Carolina Power & Light Company

OG-137  
Ref: OG-110,  
12/1/83 &  
OG-117  
3/9/84  
October 25, 1984

Westinghouse Owners Group  
Program to Address Generic Letter 83-10 - RCP Trip  
Response to NRC Questions

Figure 7 - SBLOCA Cold Leg Mass Flow (Intact Loop) (LBM/SEC)

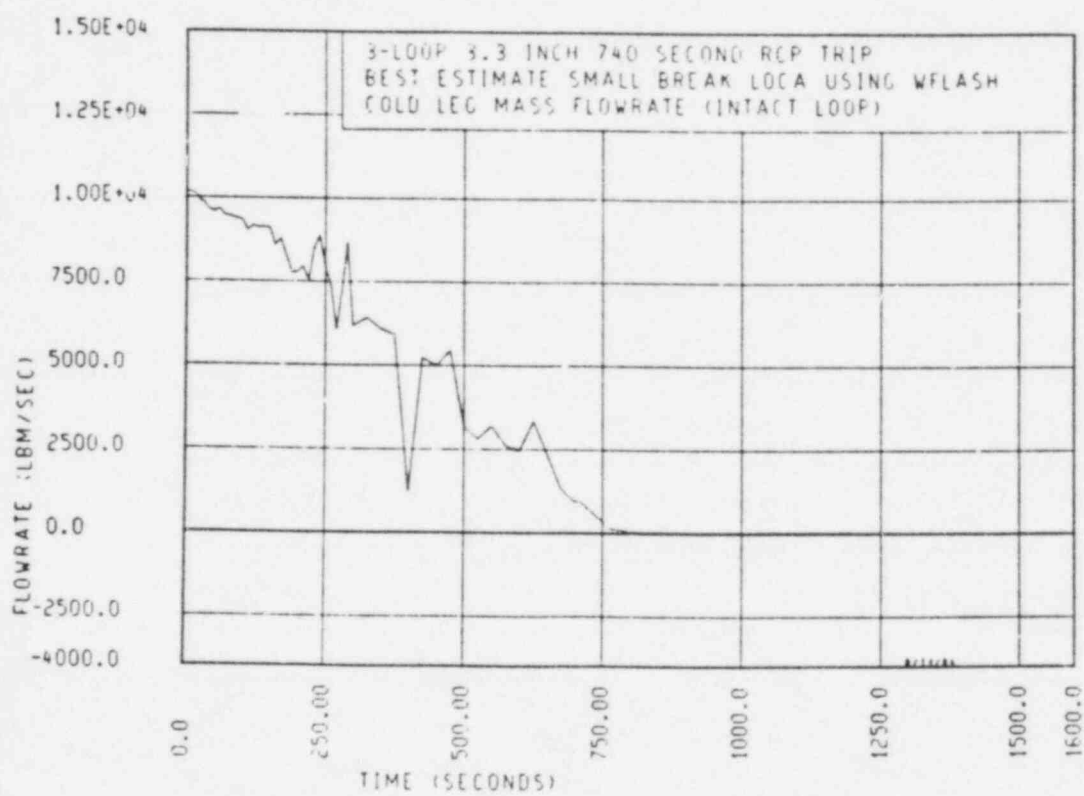
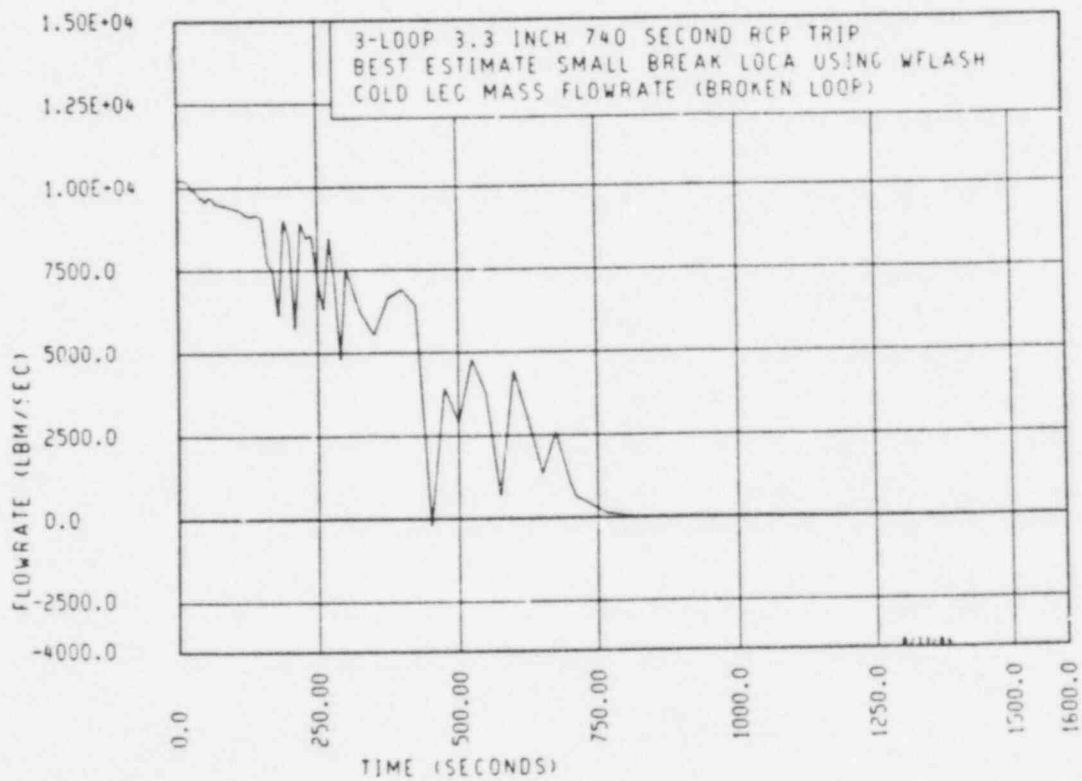
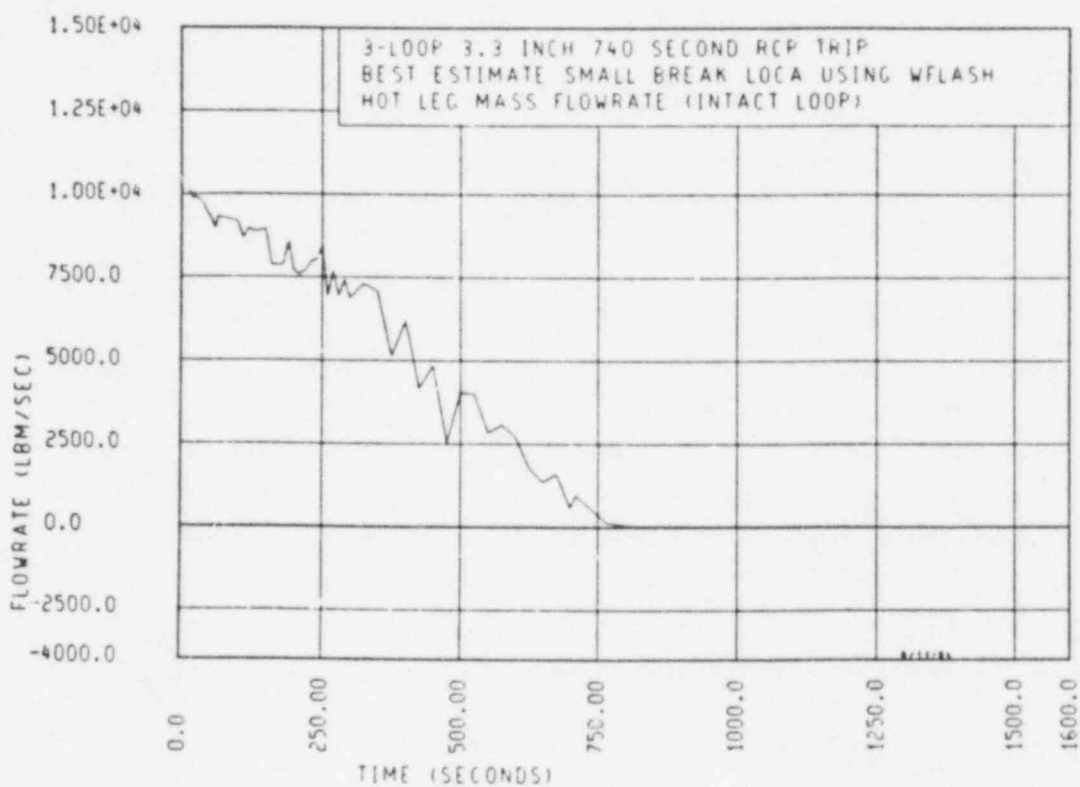
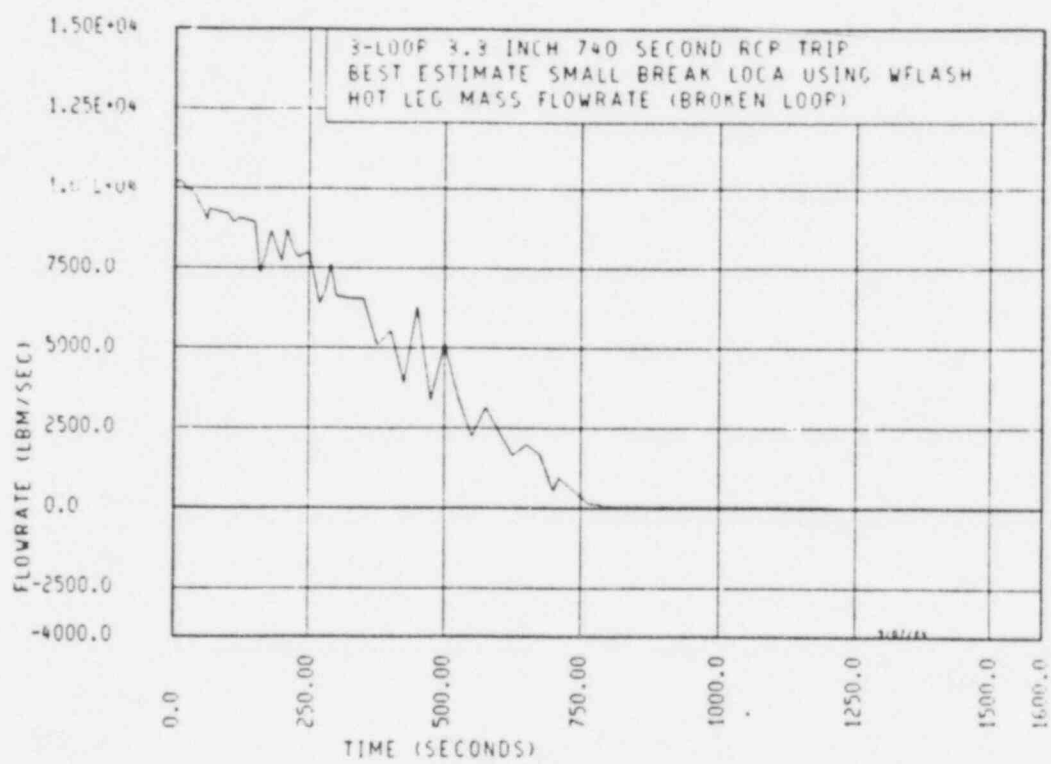
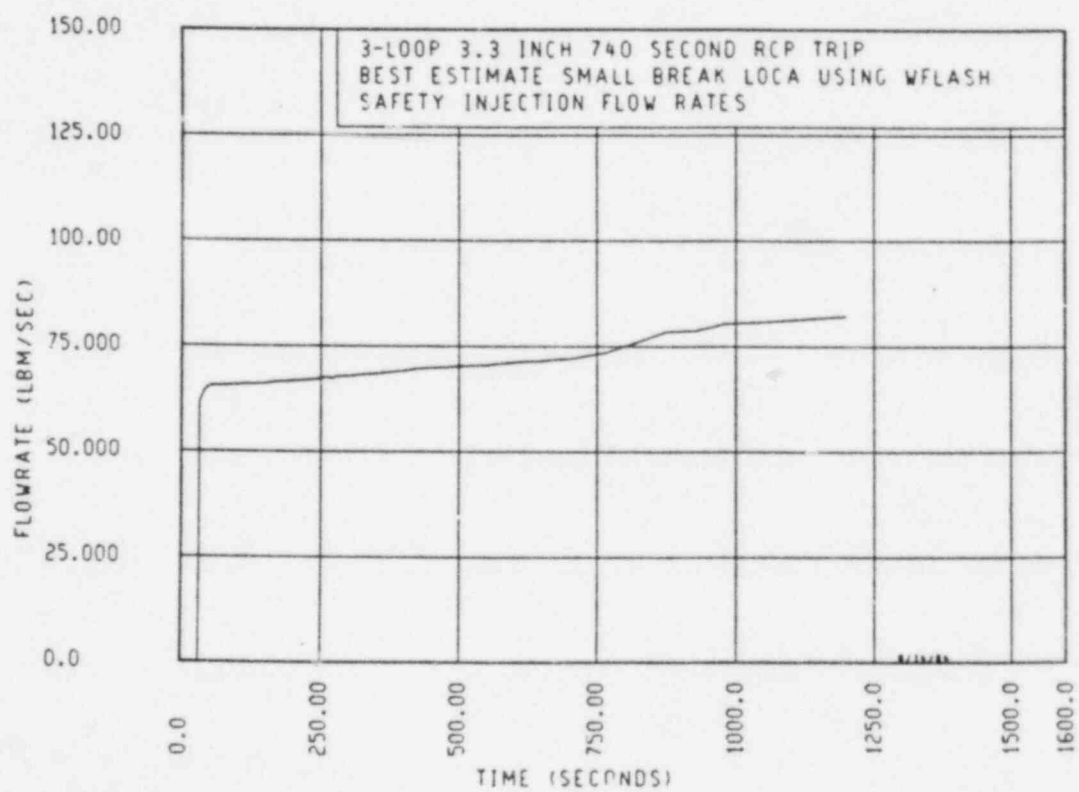
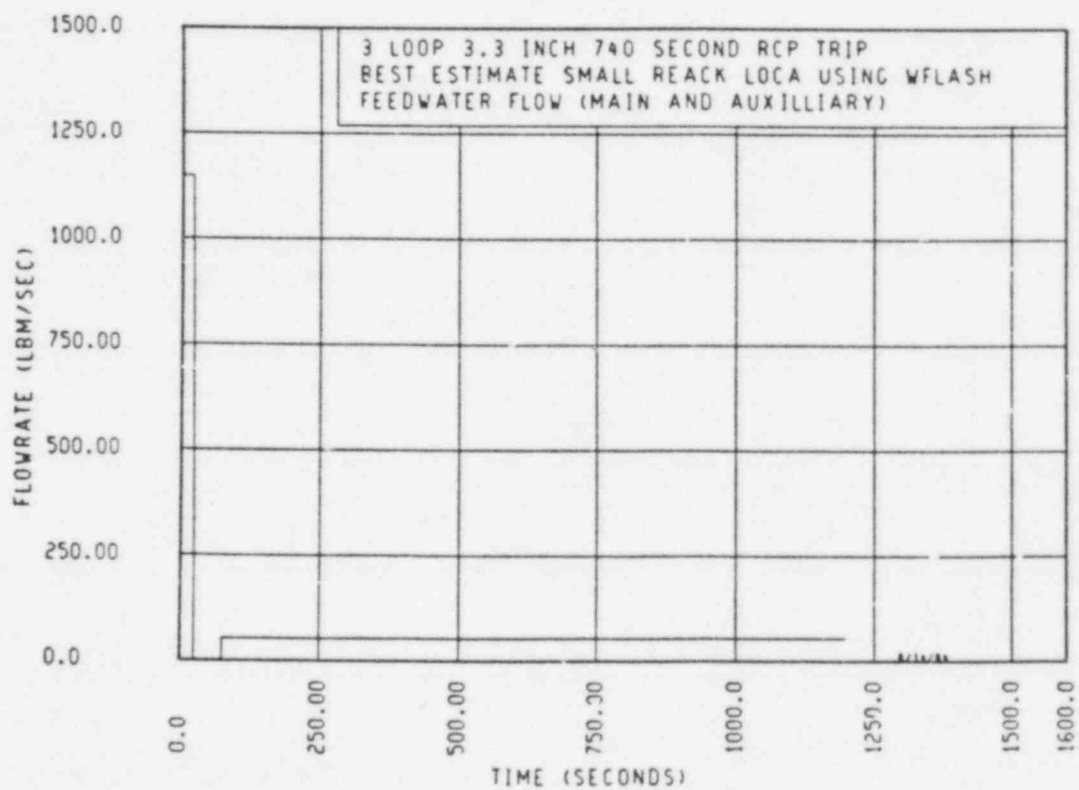
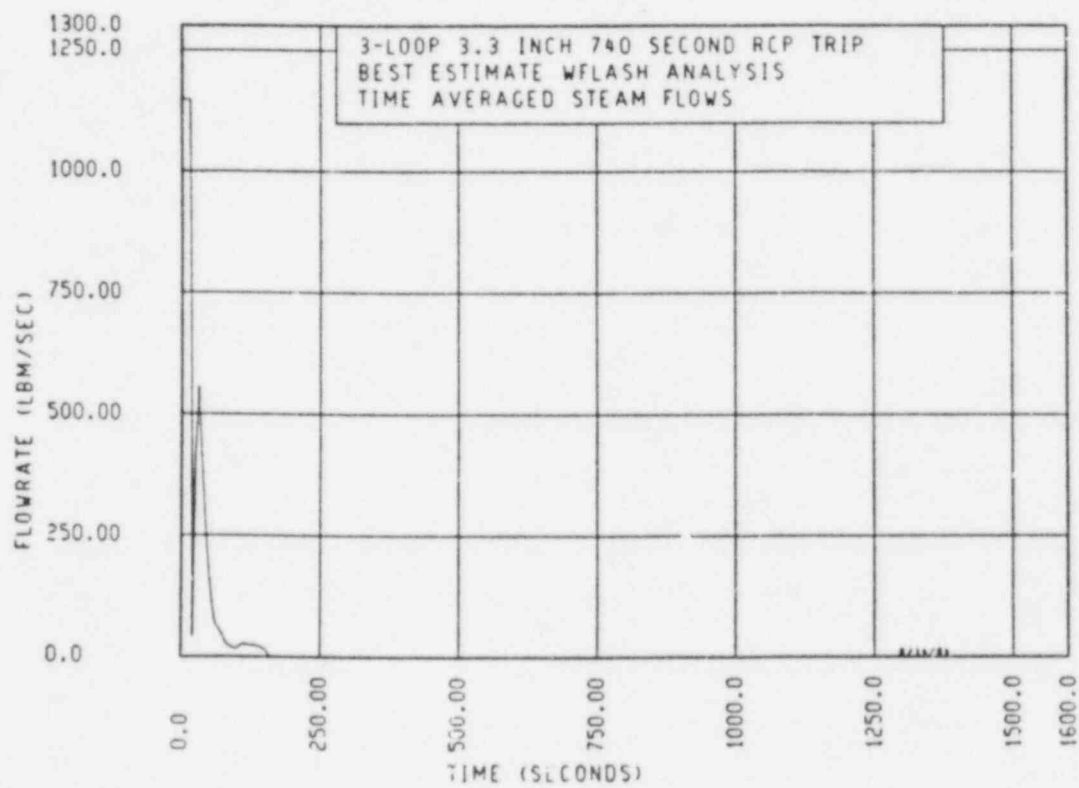
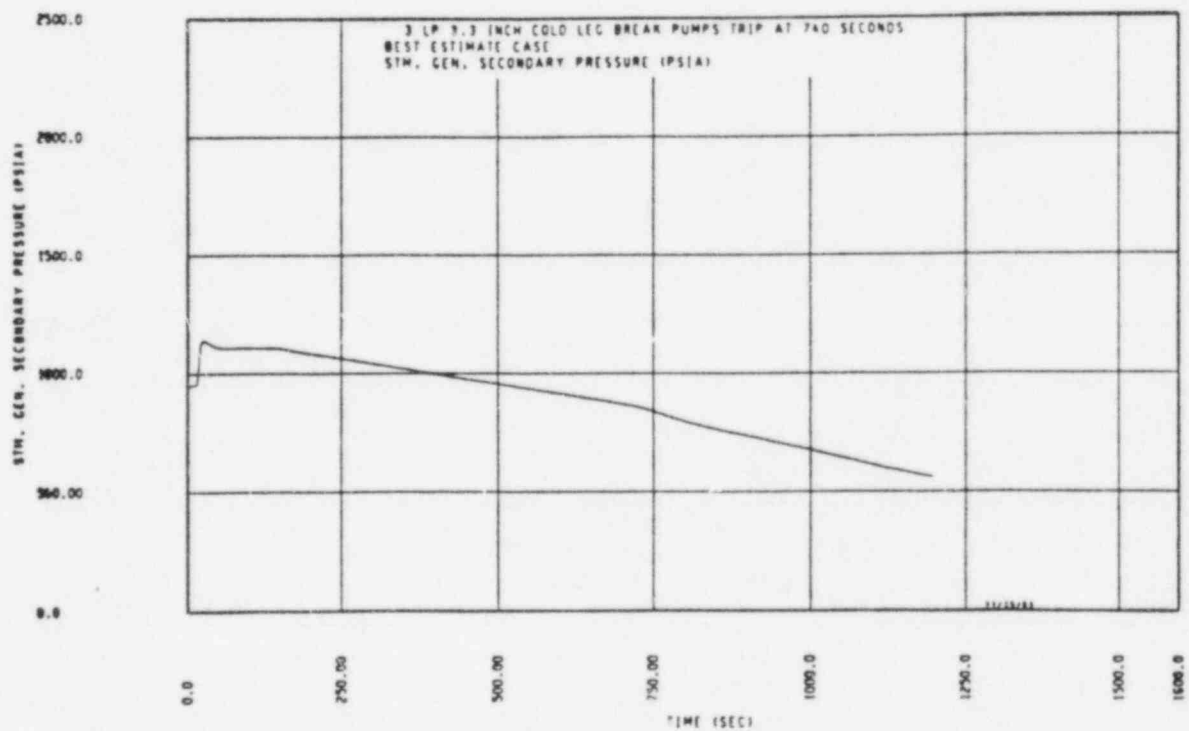
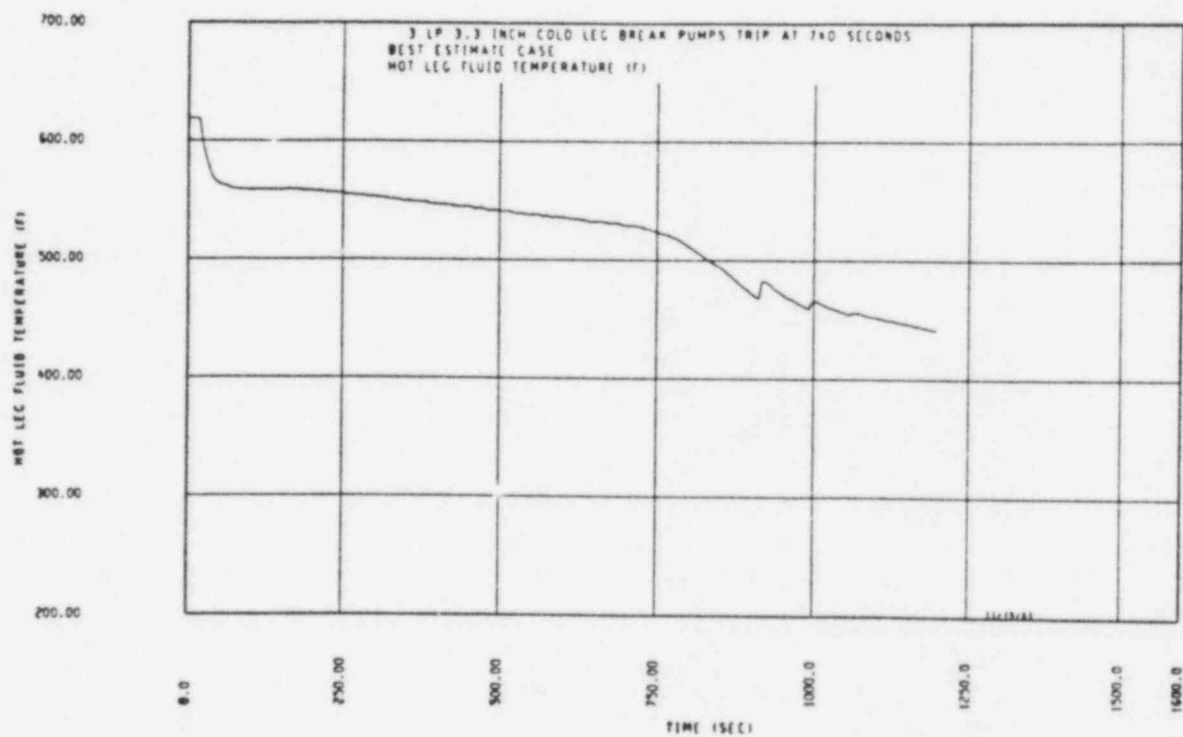
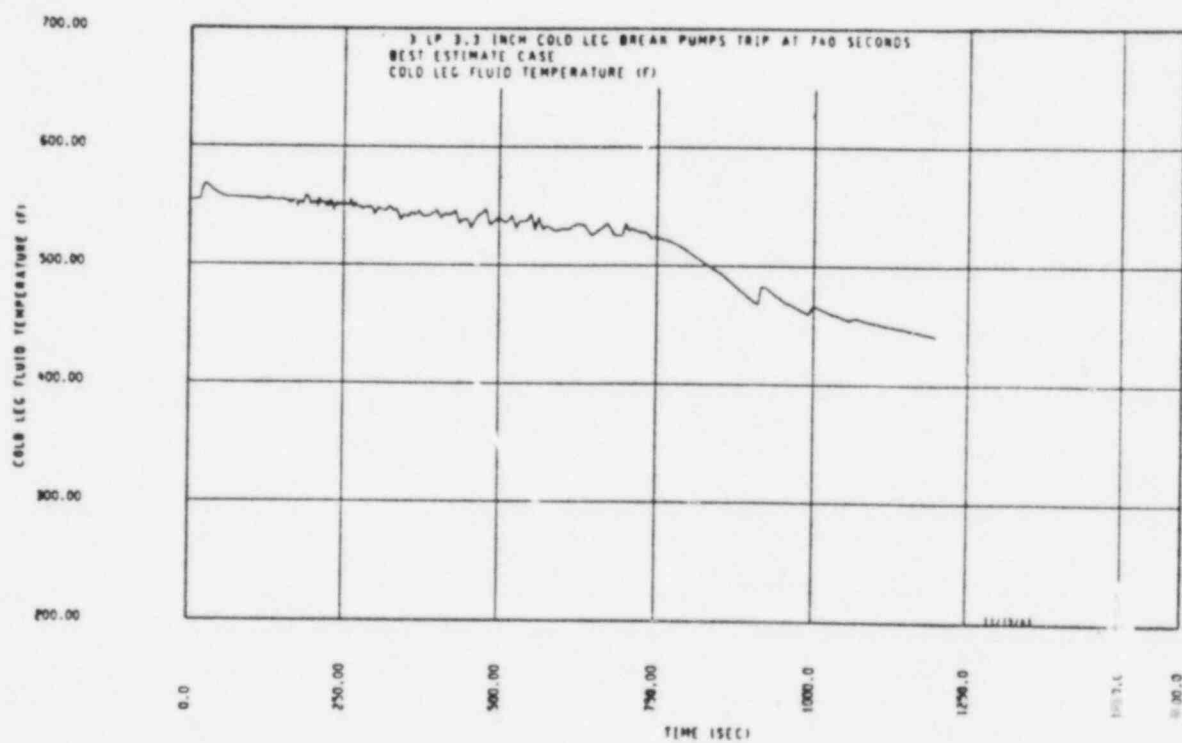
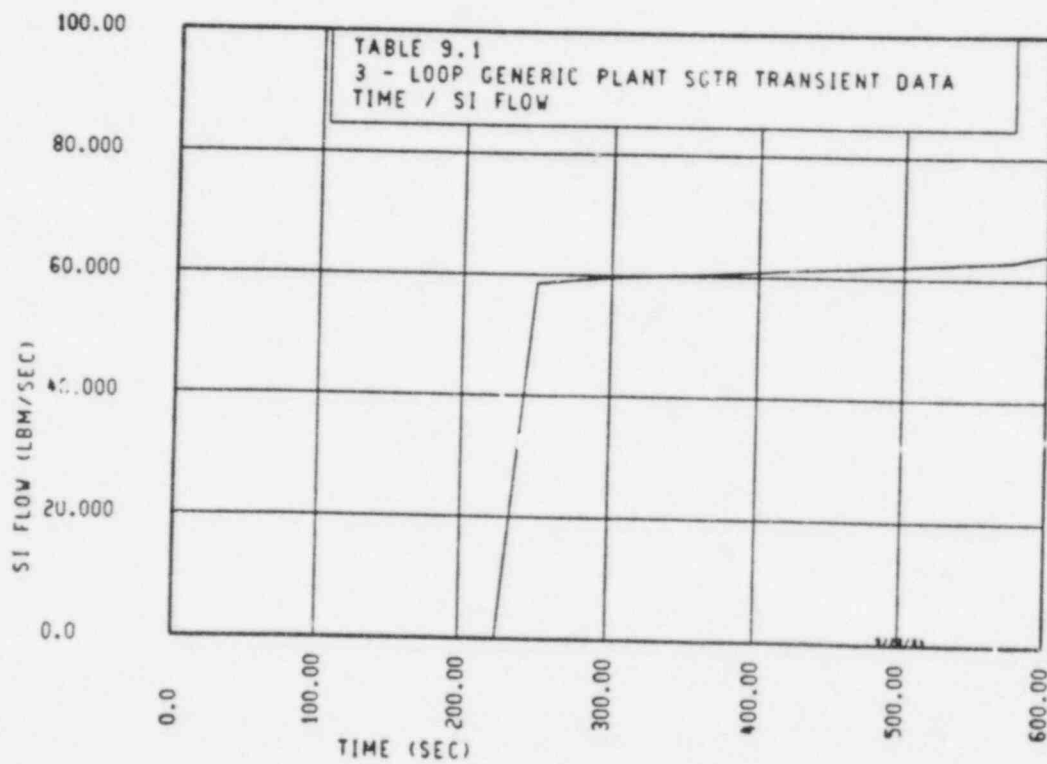
Q.73 We will be performing independent, confirmatory analyses of selected SBLOCAs and SGRs. In order to benchmark our calculations, please provide plots of the following parameters for the 3-loop generic PWR, for the 3.3 inch diameter SBLOCA and for the design base SGTR (where noted (\*)) these data were presented in the submittals for the SBLOCA case, .

- 1) RCS pressure - Figure 1
- 2) Secondary side pressure, ruptured - Figure 2  
Secondary side pressure, intact - Figure 21
- 3) Hot leg and cold leg temperatures, ruptured - Figure 3  
Hot leg and cold leg temperatures, intact - Figure 4
- 4) Core mixture level - Not applicable
- 5) SGTR rupture mass flow rate - Figure 3L Case 3 of Ref. 3
- 6) Integrated SGTR rupture mass flow rate - Figure 20
- 7) Hot rod temperature - Not applicable
- 8) RCS loop mass flow rate, ruptured - Figure 19  
RCS loop mass flow rate, intact - Figure 19
- 9) Steam flow rate, ruptured - Figure 5  
Steam flow rate, intact - Figure 6  
Total feedwater flow rate, ruptured - Figure 18  
Total feedwater flow rate, intact - Figure 18
- (10) Total Safety injection mass flow rate - Figure 17

The following pages contain the requested information in the form of graphs where applicable. It should be noted that only one figure is provided for Hot Leg Fluid Temperature, Cold Leg Fluid Temperature and Steam Generator Pressure. This is due to the fact that the variances in temperature and pressure for the figures would be imperceivable between the broken and intact loops, therefore, only one figure was provided.
